Artcraft Addition

City Plan Commission — May, 8, 2025 **(REVISED)**

CASE NUMBER/TYPE: SUSU25-00035 – Major Combination
CASE MANAGER: Saul Fontes, (915) 212-1606, FontesSA@elpasotexas.gov
PROPERTY OWNER: ASLM, LTD
REPRESENTATIVE: Conde, Inc.
LOCATION: East of Westside Drive and South of Artcraft Road (District 1)
PROPERTY AREA: 9.98 acres
VESTED RIGHTS STATUS: Not Vested
PARK FEES: \$9,980.00
EXCEPTIONS/MODIFICATIONS: Yes, see following section
ZONING DISTRICT(S): G-MU (General Mixed-Use)

ATTACHMENT 2

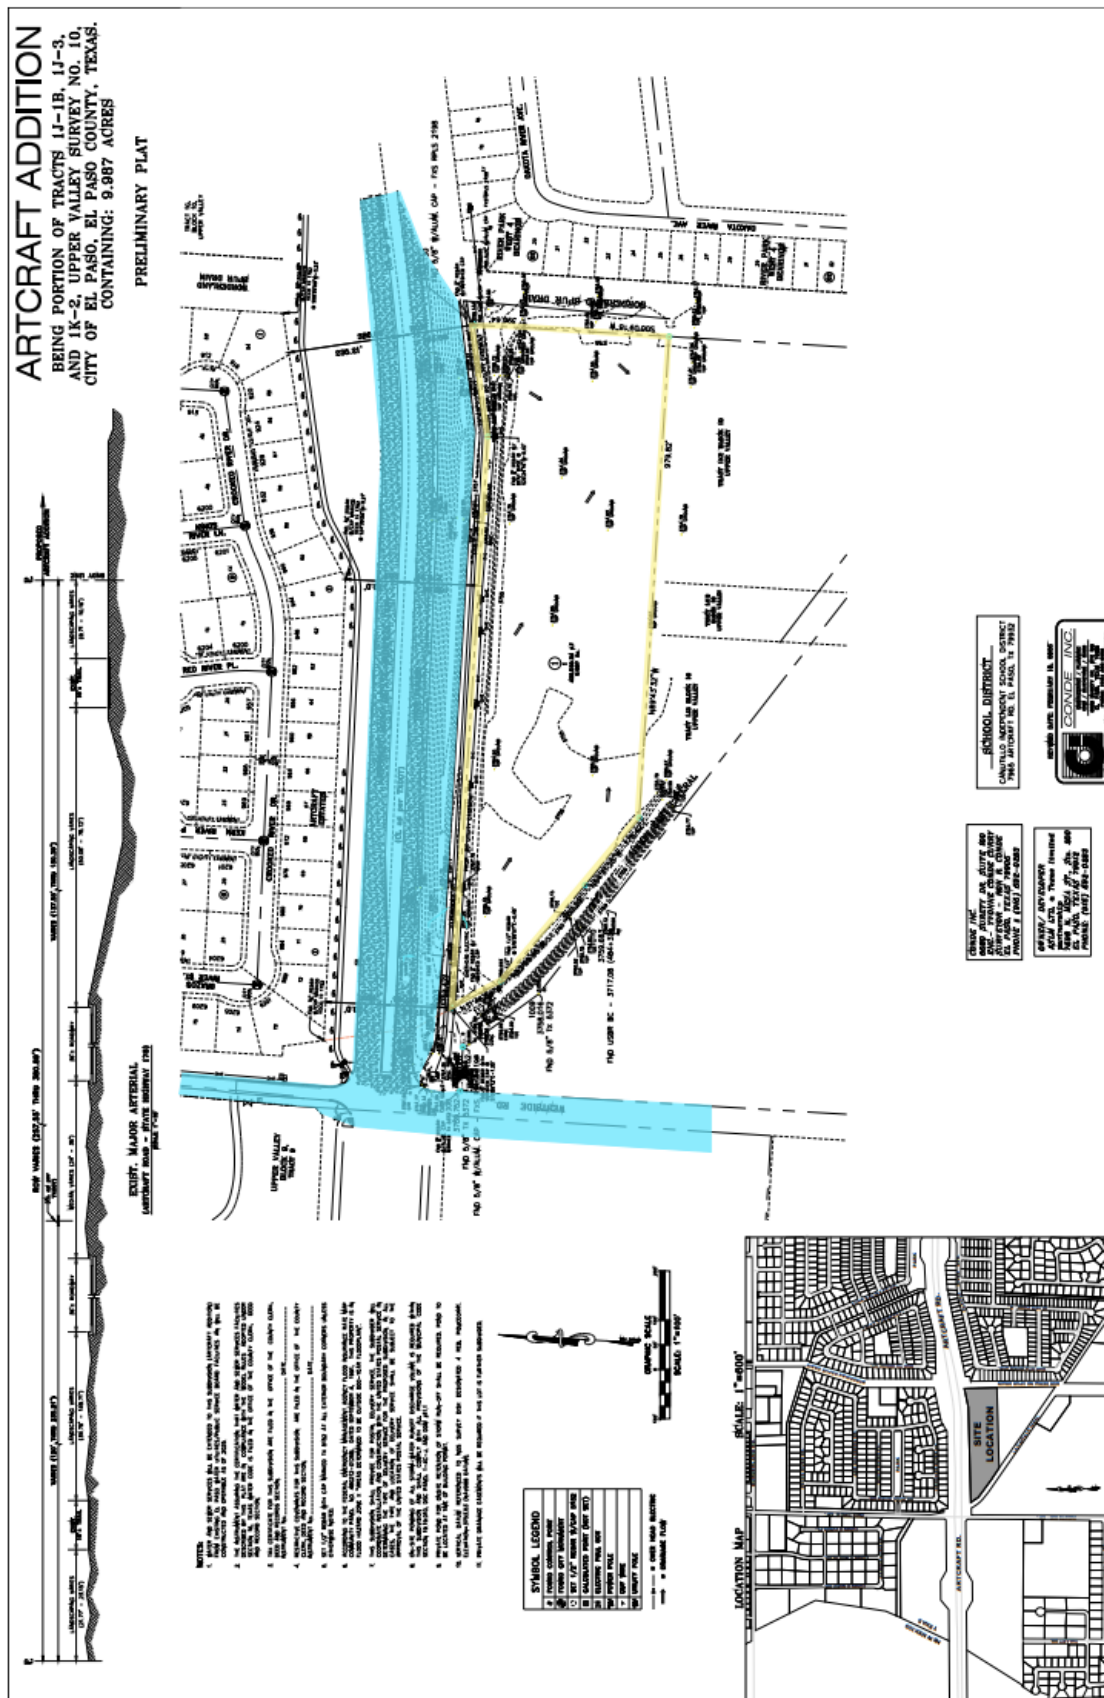
4. On the preliminary plat, provide the direction of flow of all watercourses, location, type, material, and size of any existing and proposed storm-water drainage structures and/or facilities, and provide drainage calculations.

ATTACHMENT 3

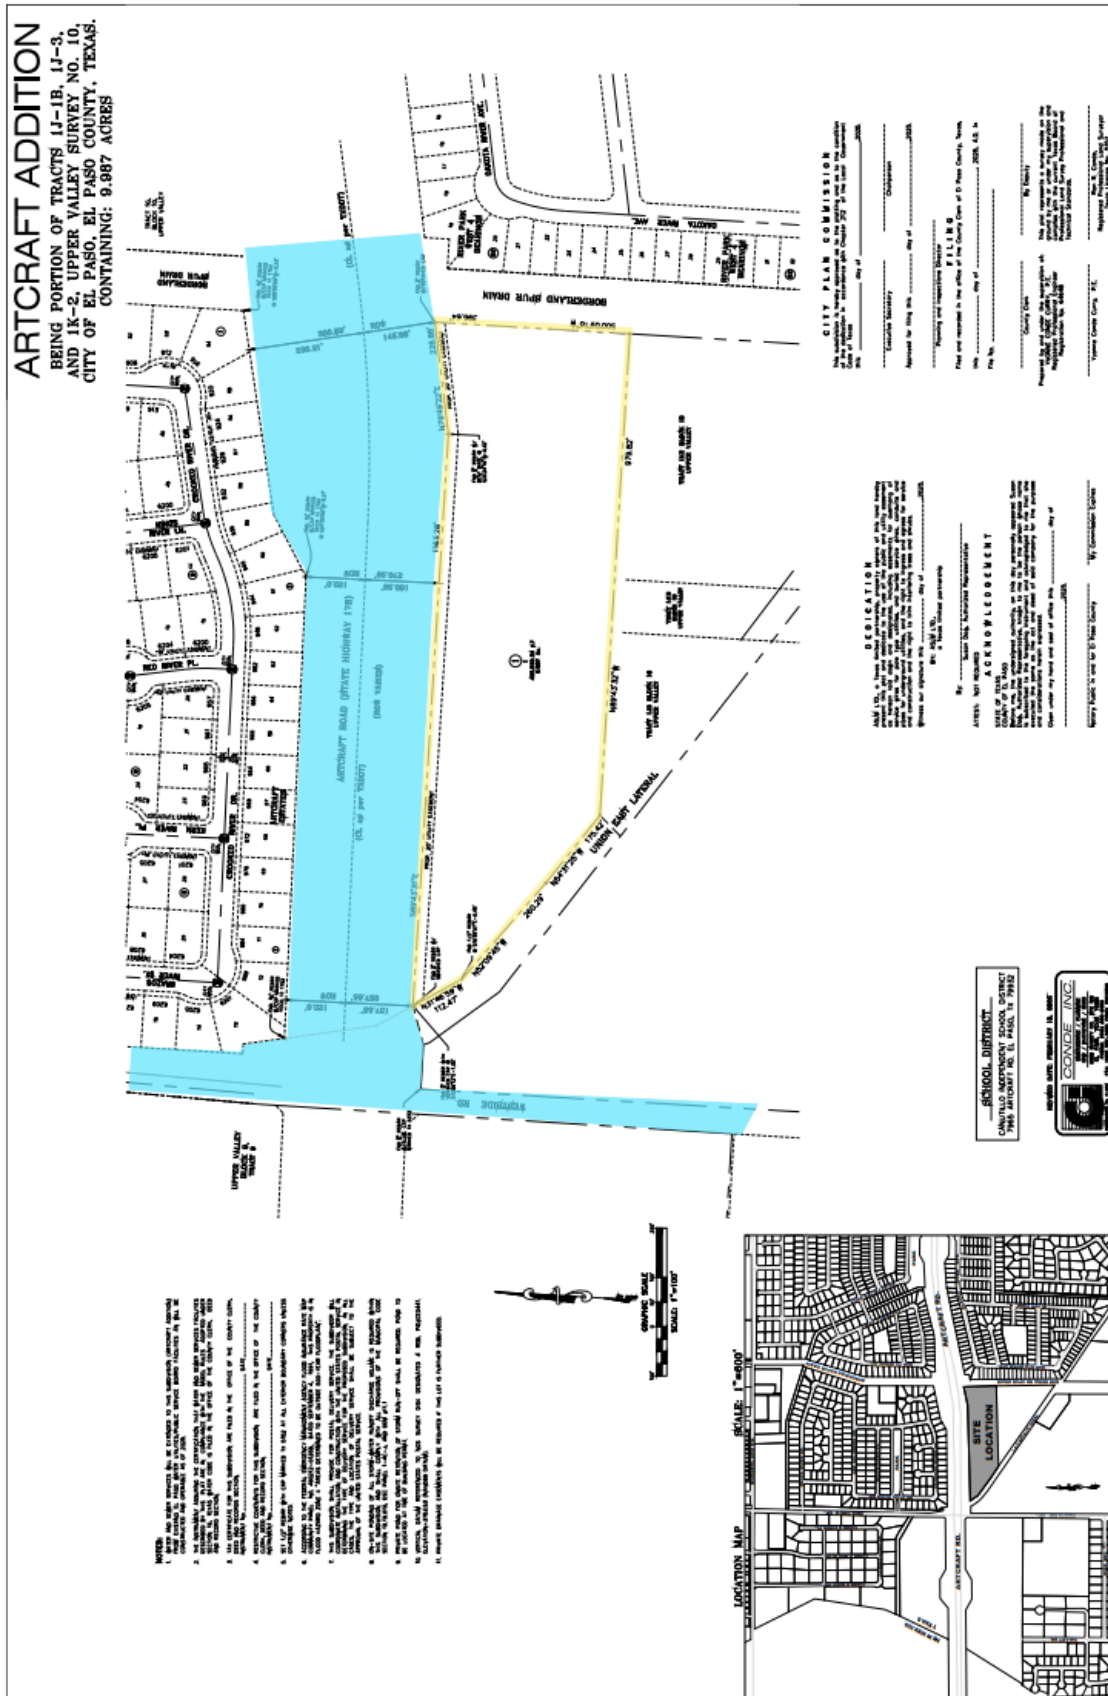
5. Remove note 4 on plat if no restrictive covenants will be provided.

1. The subdivision shall be tied to a horizontal control by bearing and distance to either a section corner, survey line, the National Geodetic Survey monument, City monument or other known and accepted survey points. This tie shall be delineated on the plats.

8. Label legal lot address.

Please change the 20' wide proposed easement to the existing 25' wide existing easement for EPE noted with instrument number **2007009715**. Please also add a 15' wide utility easement along the Borderland Spur Drain Canal for access to the lots located below the proposed lot 1 for future development.
